**City of Biddeford
Planning Board**

September 18, 2024 at 6:00 PM
City Hall Council Chambers & Zoom

9.a 2024.31 The Planning Board will hear a final site plan for Mike Eon & Associates, LTD. The project proposes to construct a 4,800 square foot building proposed as a Dentist's Office at 25 Barra Road (Map 2, Lot 43-10) in the I-3 Zone. To support this development, the project also proposes to create 25 parking spaces, in conformance with City Code, utility connections utilizing existing municipal service stubs on the property, and develop stormwater management systems in conformance with City standards. This property was previously granted a Site Plan approval by the Planning Board for the development of a restaurant and office building in 2016. The previously approved project was larger in scope (5,850 sqft building and 50 parking spots.

Re: 25 Barra Road – Dentist Office
Site Plan Application Response to Comments

Figure 1 Front Elevation- North

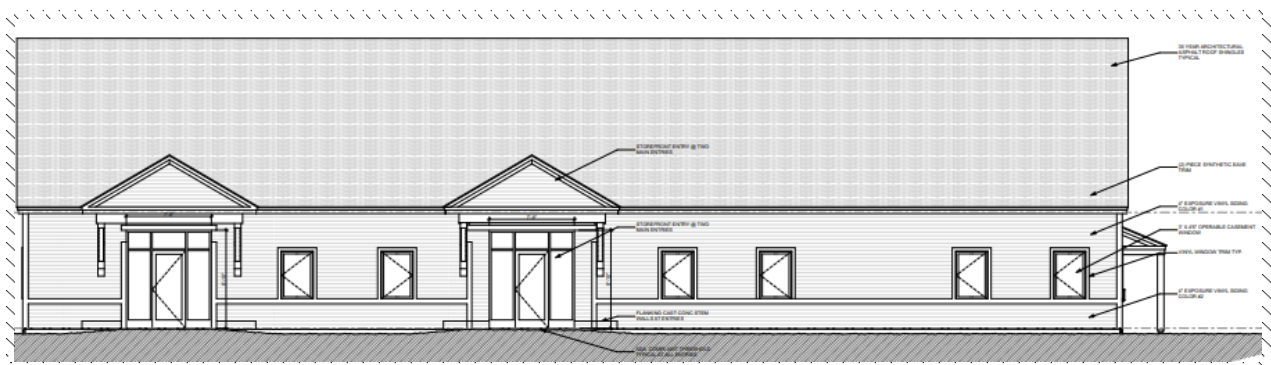
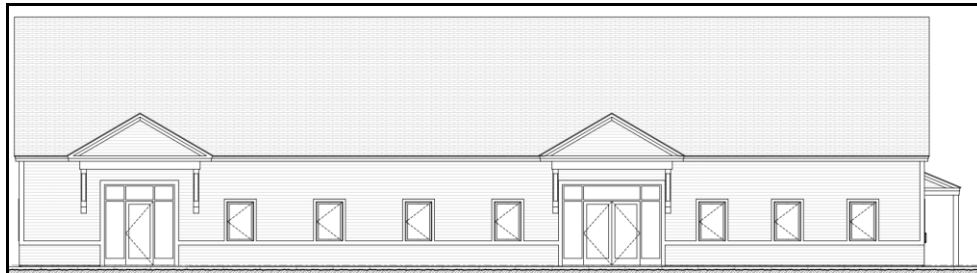
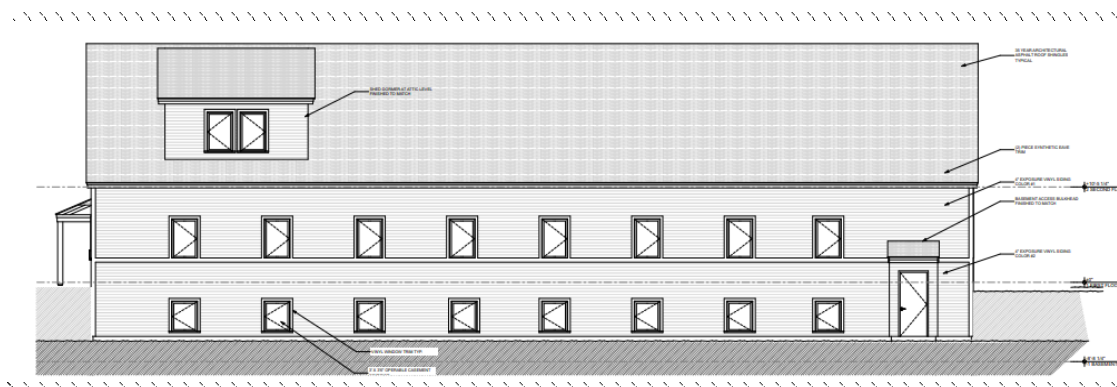
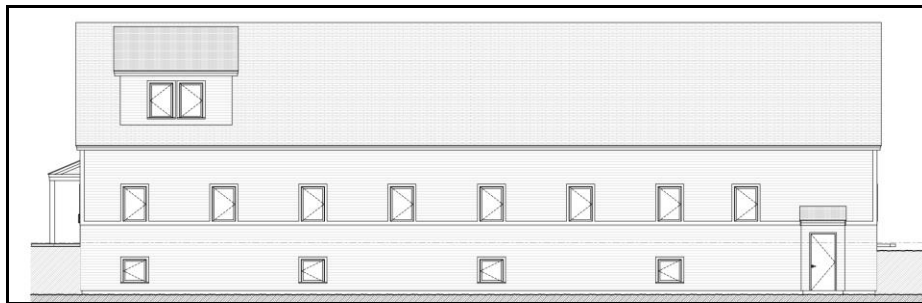
There have been changes in the building elevation except for the east side elevation. The changes revolve around window and door placement numbers.

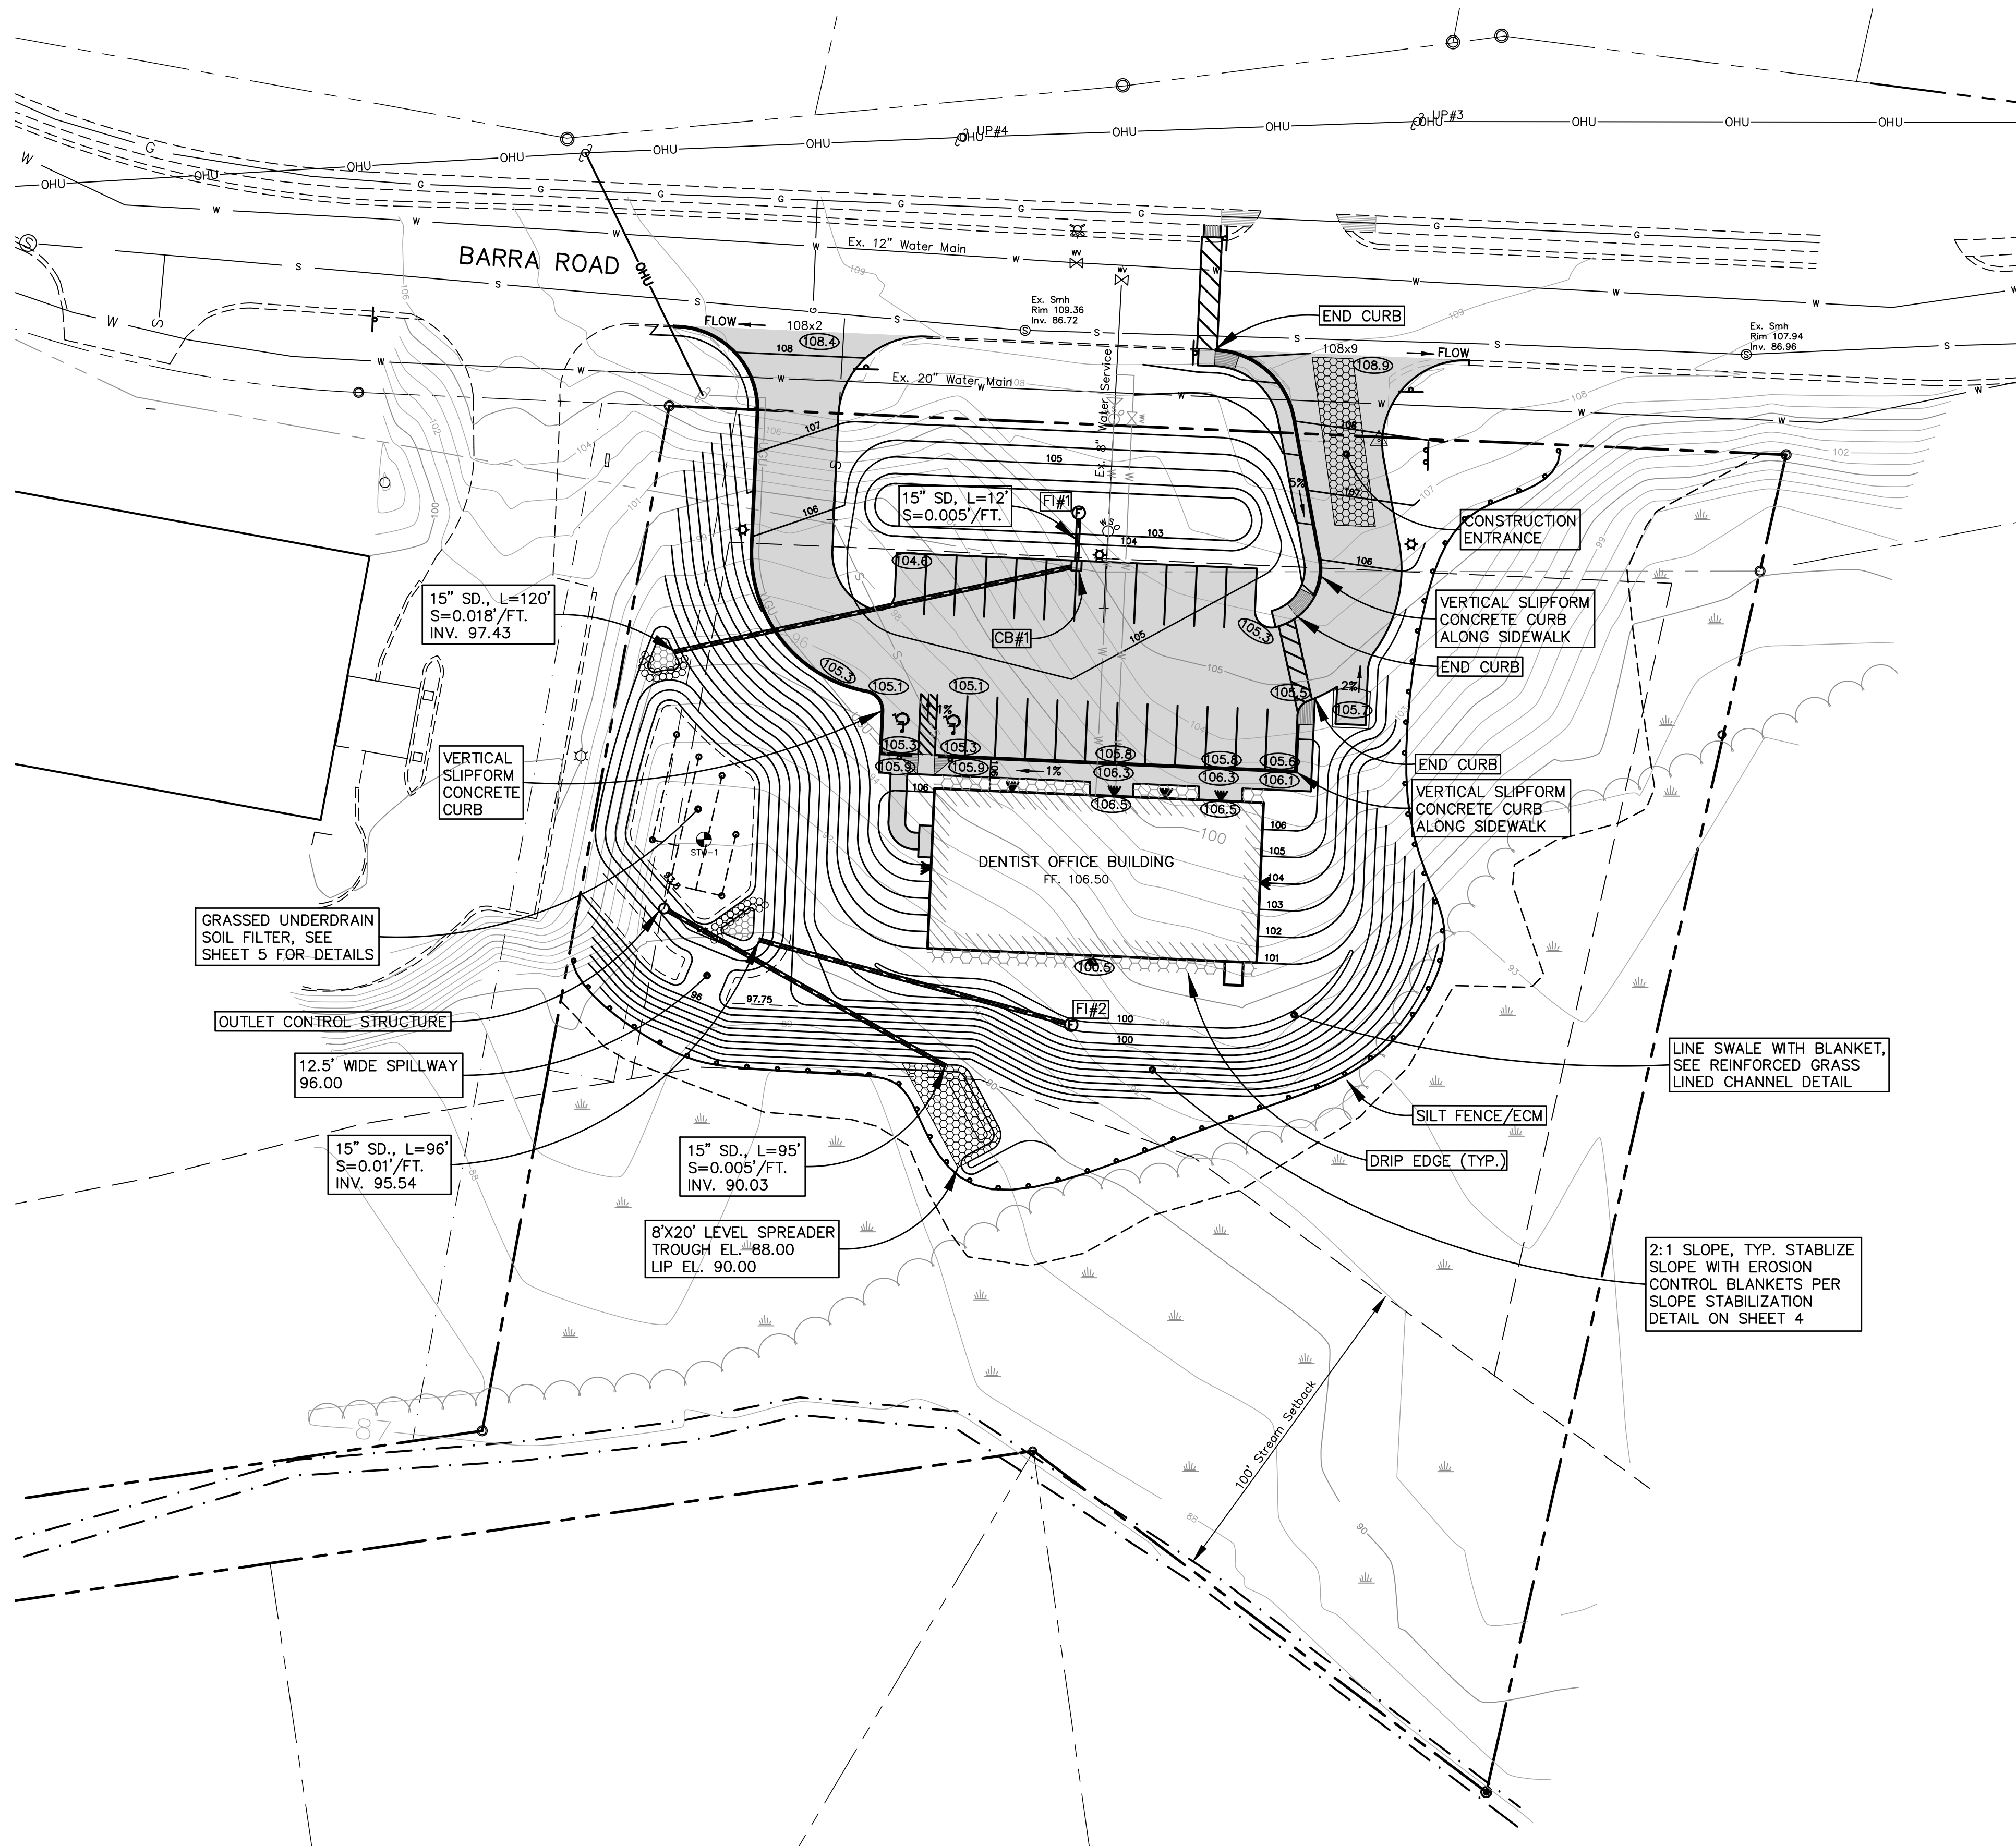
1. Sheet 1 – Site Plan

Response: A crosswalk detail has been added to sheet 6, warning strip and signage locations at the crosswalk, along with signs 250' either side of the crosswalk in conformance with MUTCD are shown on sheet 1.
